## NOTICE OF SPECIAL MEETING OF THE PLANNING AND ZONING COMMISSION HICKORY CREEK TOWN HALL 1075 RONALD REAGAN AVENUE, HICKORY CREEK, TEXAS 75065 TUESDAY, MAY 09, 2023, 6:00 PM

#### RE: Lakesound – Amended Final Plat 1<sup>st</sup> Review

#### RE: Alpha Omega Hickory Creek Addition – Site Plan Modification 1<sup>st</sup> Review

#### RE: The Reserve at Hickory Creek – Final Plat, Site and Landscape Plans 4<sup>th</sup> Review

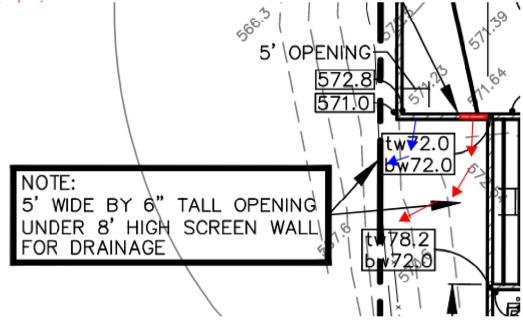
- 4. Lawn area around the existing building to remain in the northern area is reduced for proposed additional paved area. This results in the landscaped area being reduced from 47,674 square feet (37.8% coverage) to 44,353 square feet (35.17% coverage). This modification still exceeds the minimum required 15% coverage.
- 5. The following additional protected tree is proposed to be removed. The applicant will need to mitigate according to Town ordinance requirements.

a. Tree #42 – 21" Bois d'arc – mitigation required: 31.5"

6. Three proposed Chinese Pistache trees, one proposed Cedar Elm, and one Live Oak are moved to different locations on site to accommodate the modified parking area. The same number of caliper inches are proposed as in the previous plan.
